Access Compliance Report

Public Rights-of-Way

Intersection ID: 12433	Main Street: WILKINSON_BV	Cross Street: MIDLAND_AV	Location: NW
ADA ID: 6BA625CDED85	Ramp Type: ParaDiag	Initial Pass/Fail: Fail	Overall Compliance: No
		Severity Score: 12.5

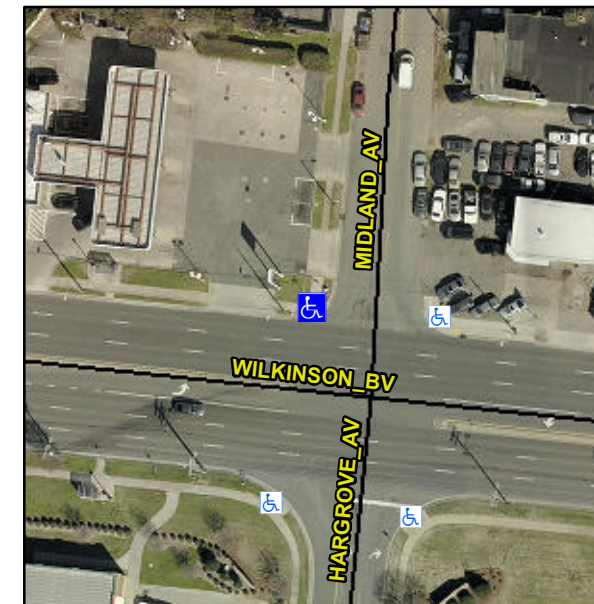
LT RP < 5%

R304.3.2

Compliance	Description	Data	Compliance	Description	Data
N/A	Ramp Length LT (in)	32.0	N/A	Ramp Length RT (in)	115.0
Yes	Ramp Width LT (in)	58.0	Yes	Ramp Width RT (in)	59.0
Yes	Ramp Slope LT (%)	3.2	No	Ramp Slope RT (%)	8.6
Yes	Ramp XSlope LT (%)	2.0	Yes	Ramp XSlope RT (%)	0.2
N/A	Landing Length (in)	N/A	N/A	DWS Provided?	N/A
N/A	Landing Width (in)	N/A	N/A	DWS Contrast?	N/A
N/A	Landing Slope (%)	N/A	N/A	DWS Length (in)	N/A
N/A	Landing X Slope (%)	N/A	N/A	DWS Full Width?	N/A
N/A	Landing Curb? (Y/N)	N/A	N/A	DWS Offset (in)	N/A
N/A	Shared Landing?	N/A			
N/A	Gutter Ponding?	N/A	N/A	Gutter Slope (%)	N/A
N/A	Gutter Lip Ht (in)	N/A	N/A	Gutter X Slope (%)	N/A
N/A	Painted X Walk1?	No	N/A	Painted X Walk2?	No
	X Walk 1 Direction	To S		X Walk 2 Direction	To E
N/A	X Walk 1 Width (in)	N/A	N/A	X Walk 2 Width (in)	N/A
	X Walk 1 Slope (%)	2.1		X Walk 2 Slope (%)	5.3
	X Walk 1 X Slope (%)	2.7		X Walk 2 X Slope (%)	0.4
N/A	Ramp inside XWalk1?	N/A	N/A	Ramp inside XWalk2?	N/A

Remove & Replace Curb Ramp With Two New Directional Ramps or Equivalent.
